Date: 2017-05-03

## ENGINEERING CHANGE REQUEST

# WP11: 11 T DIPOLE FULL ASSEMBLY POINT 7

Figure 1 — Picture of area under change, 8.L7 at R72 – present MB.B8L7

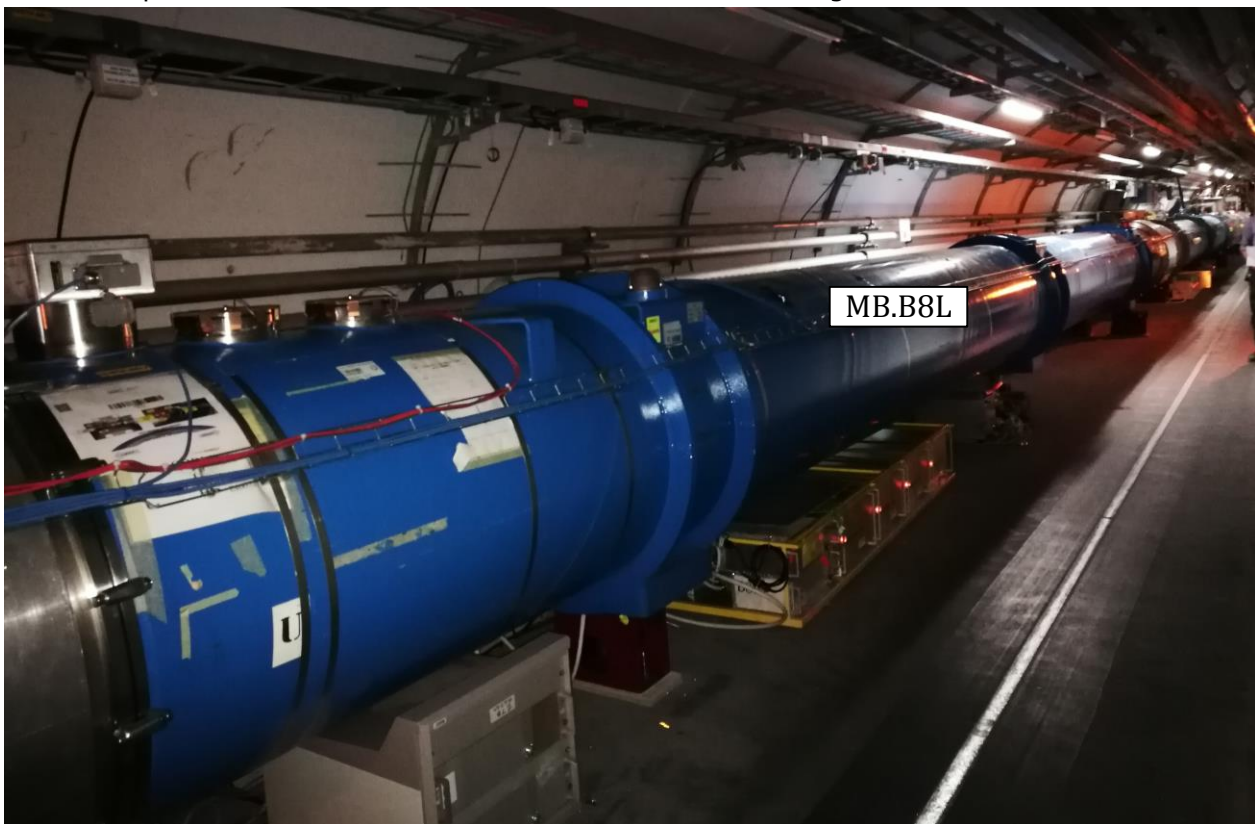
The present state of the concerned areas is shown in Figures 1 and 2.

- Removal of the present main dipole **MB.B8L7** (LBARA.8L7, circuit RB.A67)
- Installation of the 11T dipole full assembly at the MB place. The assembly is composed of two dipoles of equal bending strength and shorter magnetic length (Cryo-assembly A and B) and a bypass cryostat in the middle, providing cryogenic and electrical continuity between them.
- After that, installation of a new TCLD collimator between the two magnets, on the beam line 2 (internal beam, or passage side) will follow.

- Removal of the present main dipole **MB.B8R7** (LBBRB.8R7, circuit RB.A78)
- Installation of the 11T dipole full assembly at the MB place: Cryo-assembly A and B, and a bypass cryostat in between.
- After that, installation of a new TCLD collimator between the two magnets, on the beam line 1 (external beam, or QRL side) will follow.

Figure 3. Main dipole circuit RB.A67 configuration for the HL-LHC with the 11T trim power converter.

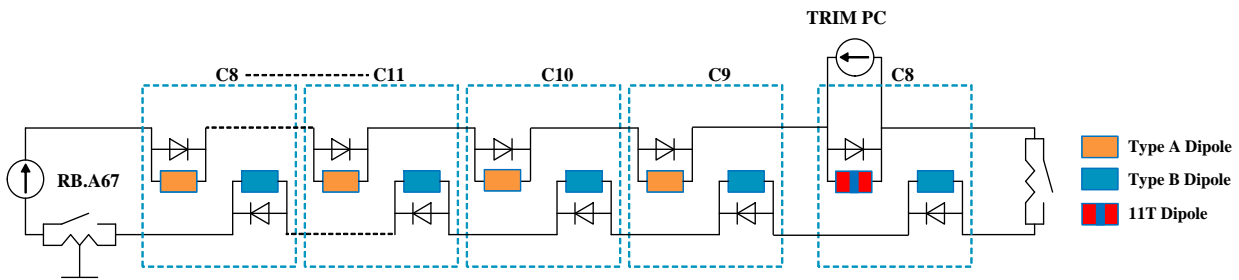
The modified circuit layout of RB.A67 (with trim circuit **RTB8.L7**) and RB.A78 (with trim circuit **RTB8.R7**) is shown in Figure 3 and 4. A detailed description of the circuits is provided in EDMS 1764166, Section 2.1-2.7. The RB circuit characteristics before and after the change are summarized in Table 5. For the circuit RB.A78 the 11 T dipole full assembly will be placed after the second energy extraction system, creating a little dissymmetry in the RB circuit.

Figure 5. Location of the new DYPB for the 11T dipoles.

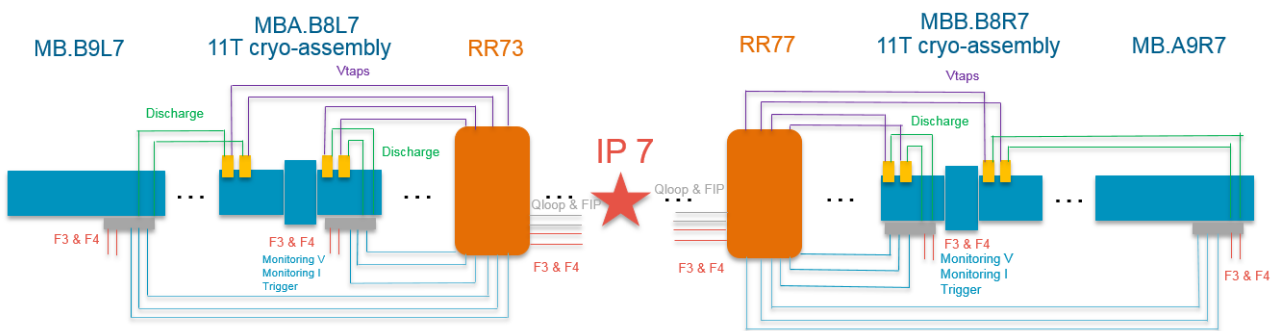
The racks will be placed around P7 of LHC. For the right side, there will be a rack underneath the 11 T cryostat before the collimator (LBHRC) from the IP, and another one under MB.B9L7 (see the grey boxes in Fig. 5). For the case of the left side, one rack will be also installed below the 11 T dipole cryostat before the collimator (LBHRB) from the IP, and another rack under MB.A9R7. There will be a total of four racks installed in the machine, however one more unit (to be considered as spare) will be manufactured.

Figure 6. Relocation of the DYPQ that needs to be moved due to the high radiation doses.

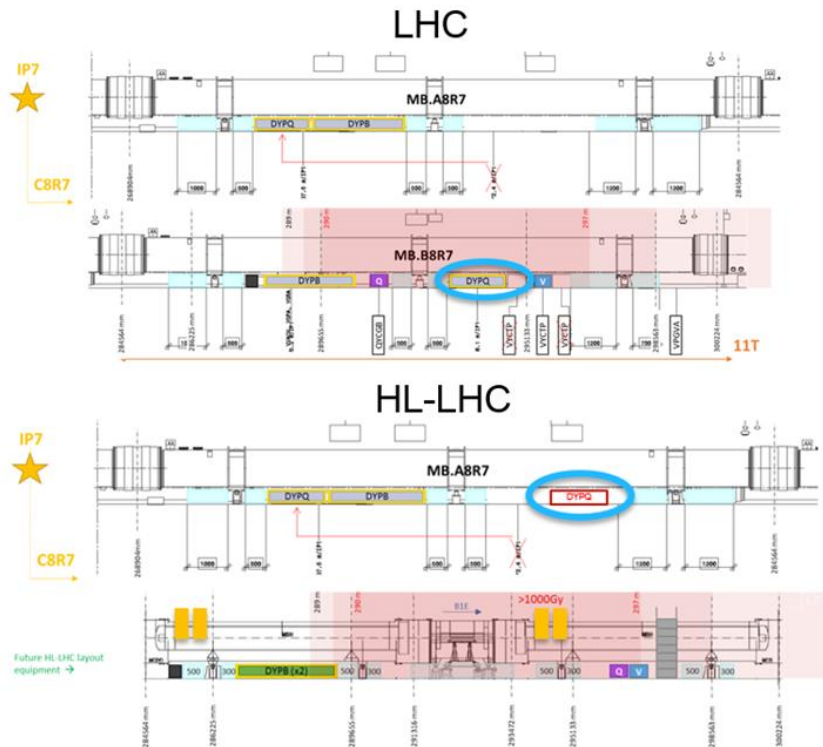
Moreover, there is today a DYPQ rack located under MB.B8R7 that will be moved under MB.A8R7. This requires consequently new cabling between the quadrupole cryostat and the new position of the rack. See Fig. 6.
